Thanet Extension Offshore Wind Farm

Appendix 31 to Deadline 1 Submission: Written
Summary of Oral Case put at the Issue Specific
Hearing 2 – Shipping & Navigation

Date: January 2019

Figure 66: Risk of a fatality per individual per year.

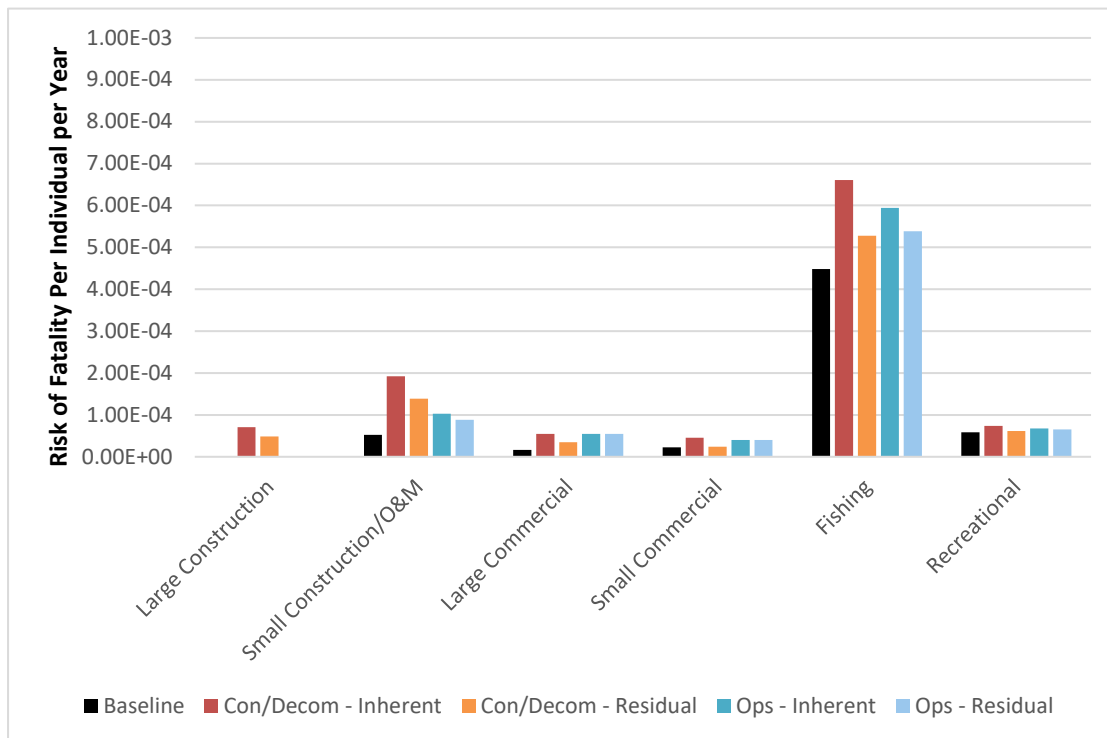
- 142 ER explained that the aggregate position was considered on the understanding that it is identified in the “2013 DTI Guidance on the Assessment of the Impact of Offshore Wind Farms: Methodology for Assessing the Marine Navigational Safety Risks of Offshore Windfarms”. There is no specific guidance on this issue but reference is made to HSE guidance which was addressed in the NRA (and is the generally accepted approach of the HSE_. Further to the FSA risk assessment section 8.6.3 “Acceptability of Risk” sought to further demonstrate the navigation hazards were tolerable when referenced to HSE guidance (HSE 1999 – Reducing Risks, Protecting People) which defined thresholds of acceptability/tolerability of:

- 1 x 10⁻³ fatalities per year for a crew person
 - 1 x 10⁻⁴ fatalities per year for a member of public
- 143 This scale has been used in other OREI NRAs see for example Kincardine Offshore Wind Farm NRA, Rampion Offshore Wind Farm NRA and Hornsea 3 Offshore Wind Farm as selected recent examples. A conservative estimate of individuals exposed was made based on each ship type taking into account all of the individual hazard likelihood and consequence scores to give an aggregate result (Baseline, Inherent and Residual). This produced NRA Figure 66, showing that all hazards by ship type fall into HSE Acceptability levels.
